Rezoning Transportation Analysis

Petition Number: 2017-145

General Location Identifier: 0713199, 04713157

Date	Description
10-24-2017	First Review

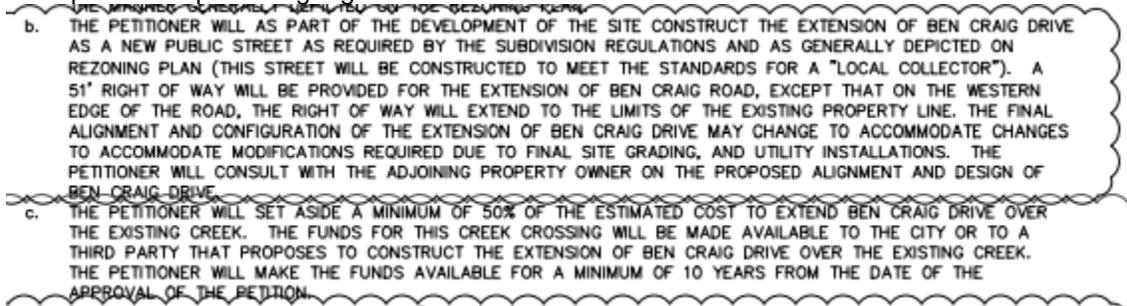
- The petitioner should revise the site plan and conditional note(s) so that all dwelling units (particularly those fronting public streets) are alley loaded to create a sidewalk that is uninterrupted by driveways. This will provide an improved streetscape environment for the proposed townhome development.
